Planning Board/Board of Zoning Adjustments Public Hearing Agenda

Date: Tuesday, March 26, 2019

Meeting: **March 26, 2019**
Project: **Siena Townhomes 2**
Planner: Courtney McNair

Architectural Design Standards:

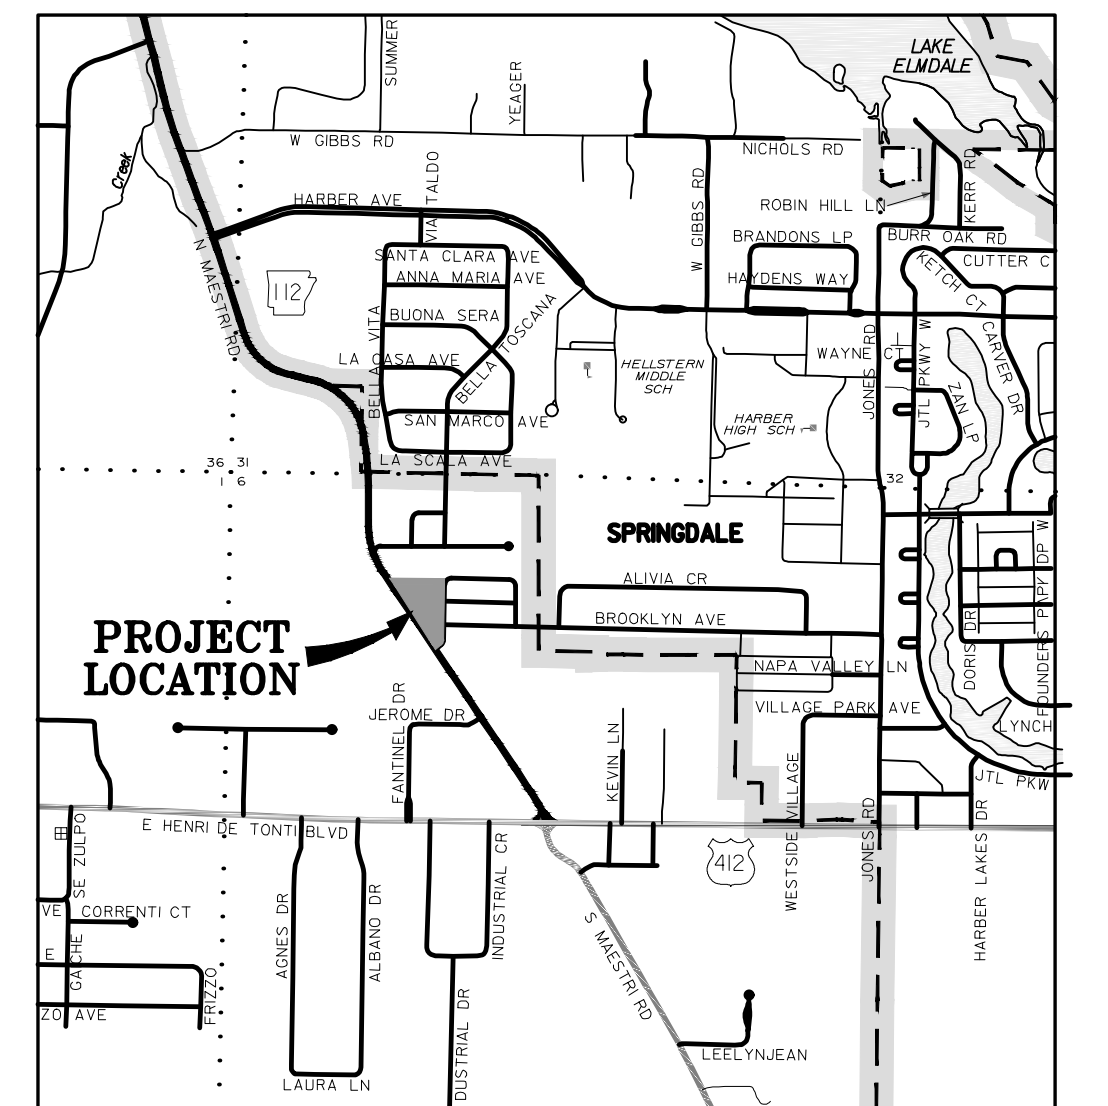
Architectural elevations were submitted. The plans submitted do appear to meet the architectural standards for Large-Scale Development projects. All facades facing N. Maestri shall be in compliance with these standards.

9. All facades facing N. Maestri shall be in compliance with the Large-Scale Development Architectural Standards.
10. Some of the plantings may need to be relocated out of the utility easements.

LSD PLAN

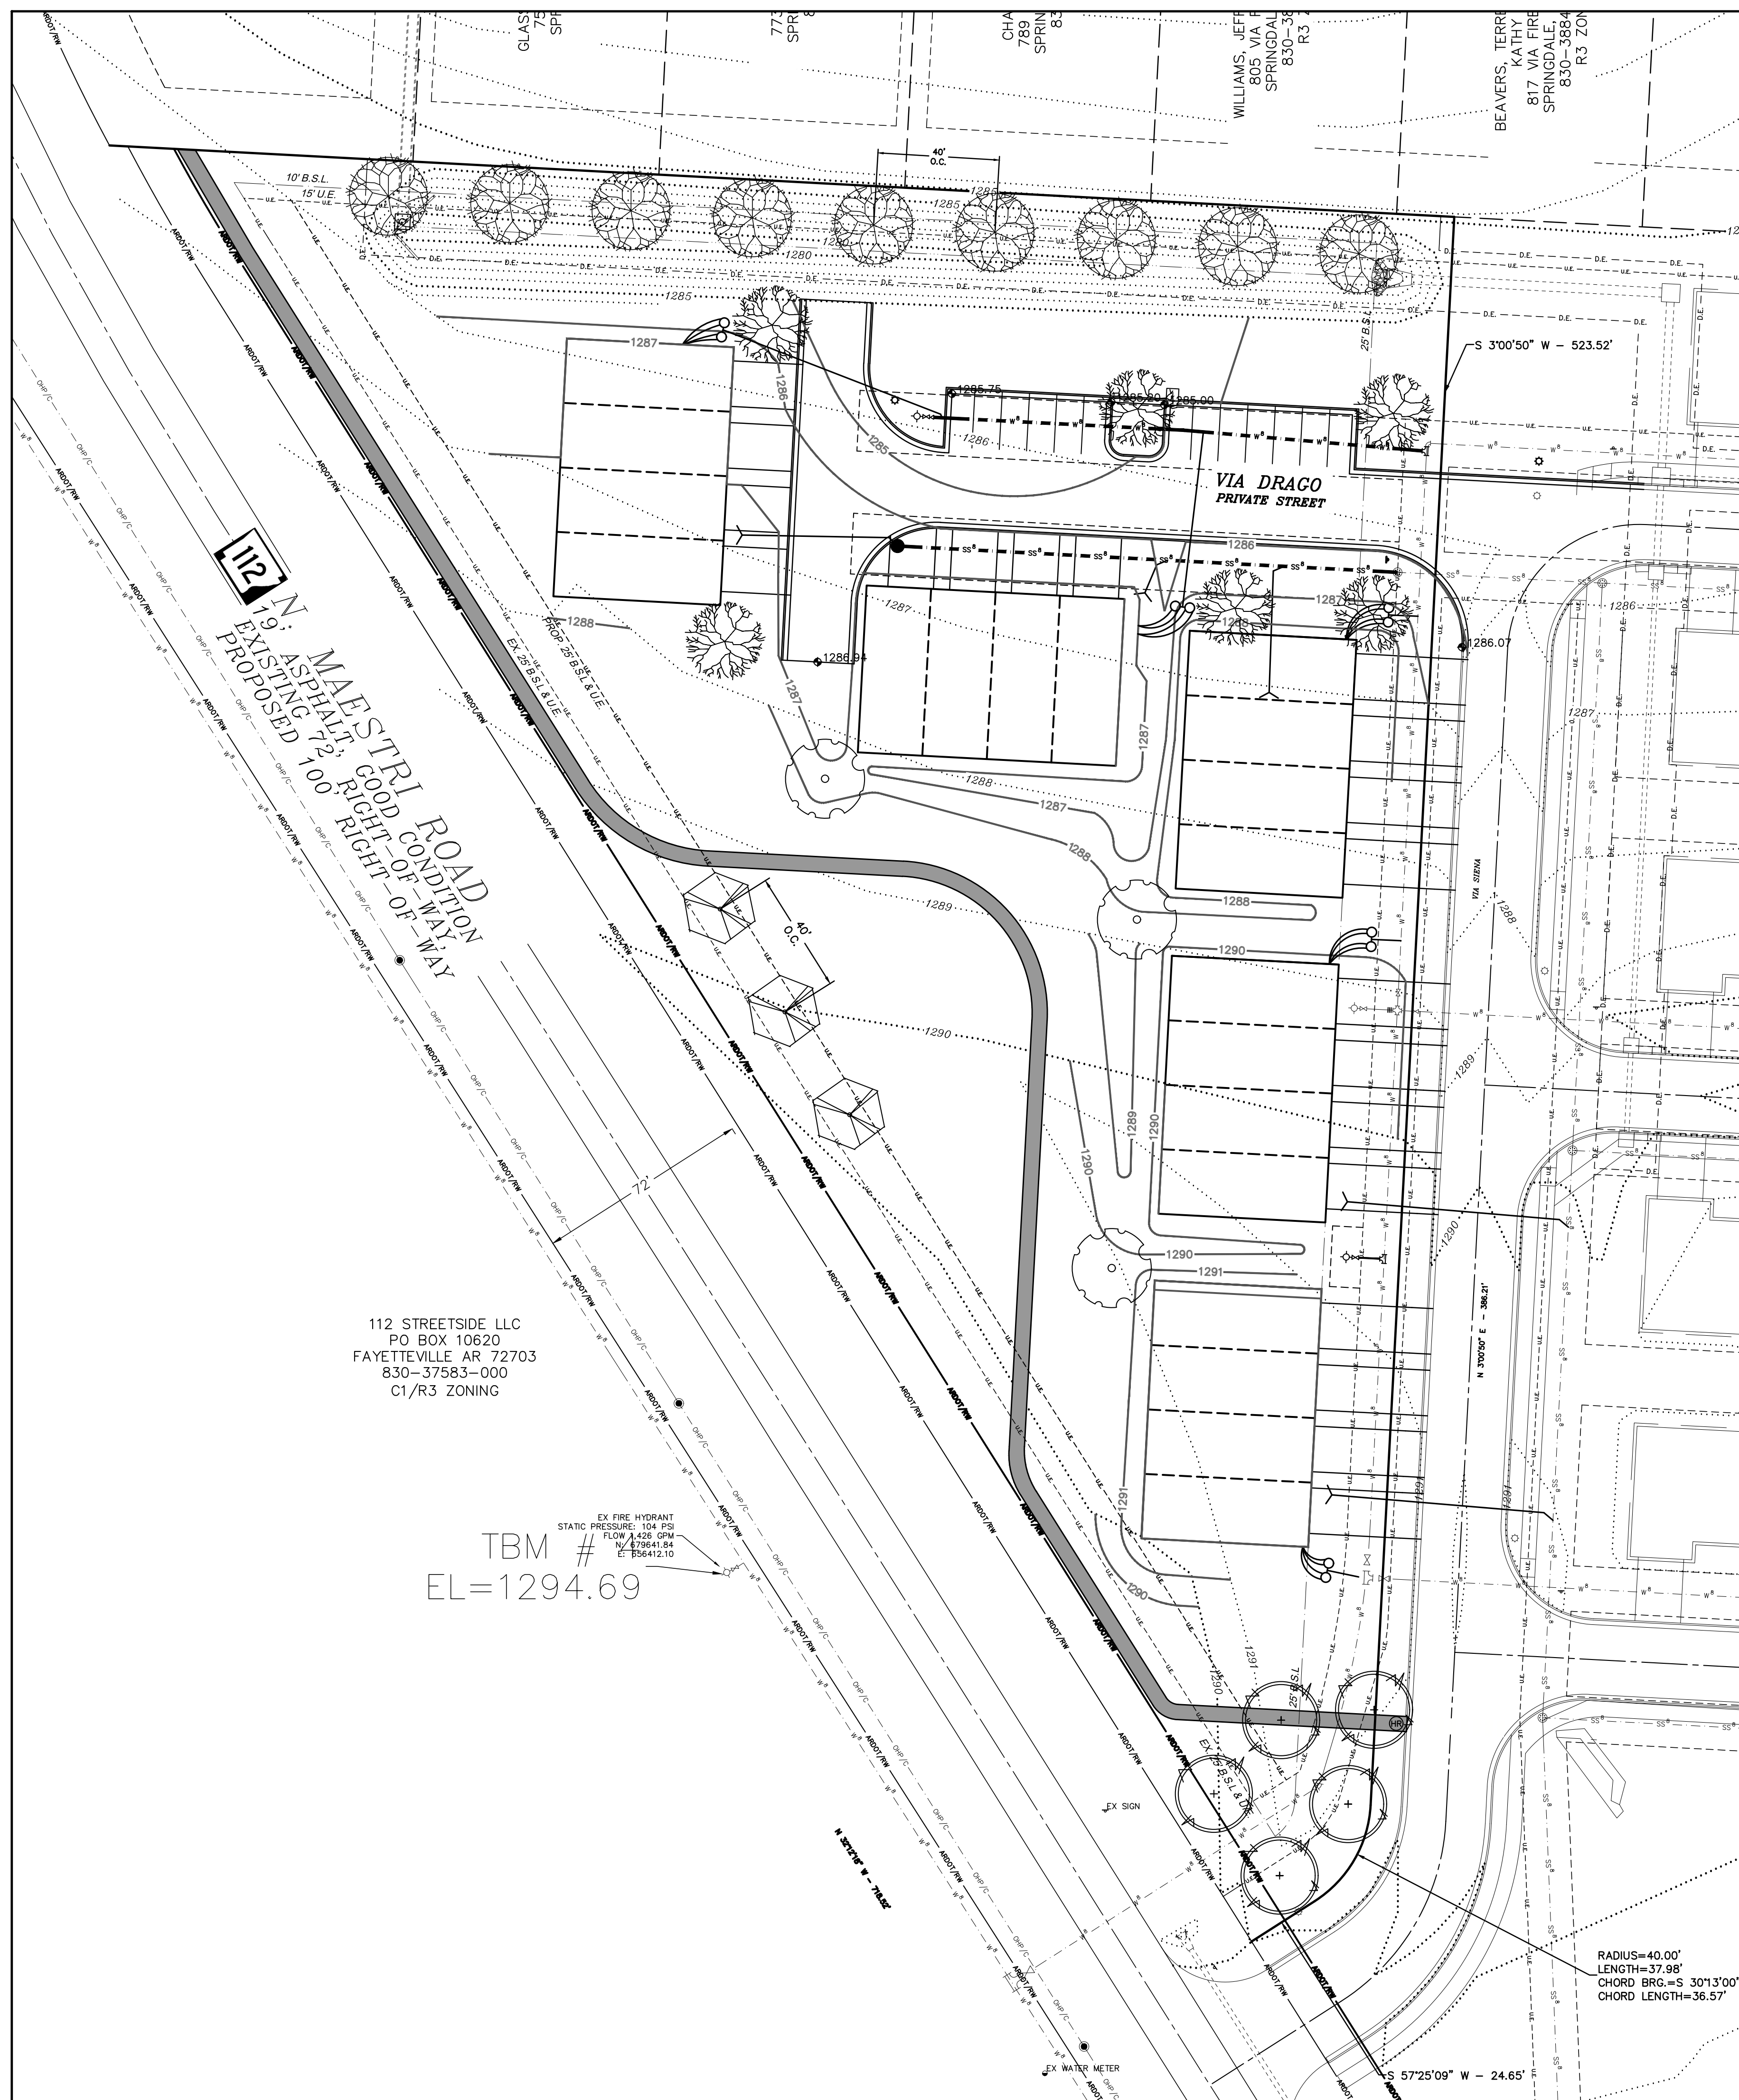
Via Siena is 30 feet wide, the extension of Via Drago will meet the existing road width of 24-feet, and there is a 20' wide, fire-access, hammerhead proposed. All turns have the required radius for fire apparatus access. Fire Lane striping is shown on the plans. All interior drives must meet the required compaction rating to support emergency vehicles.

The applicant is showing a 5-foot sidewalk along N. Maestri that meanders into the site. This must be increased to 6-feet in width to be in compliance with the Master Street Plan. Additionally, staff is not concerned overall with this placement, but will require that it continue along N. Maestri at the south of the site. Currently it is shown to turn to give access to the existing play area in Siena Townhomes Phase 1, but will also need to provide connection south along N. Maestri.

7. The sidewalk along N. Maestri shall be increased to 6-feet in width to be in compliance with the Master Street Plan.
8. The sidewalk shall continue along N. Maestri at the south of the site to provide connectivity to the south.
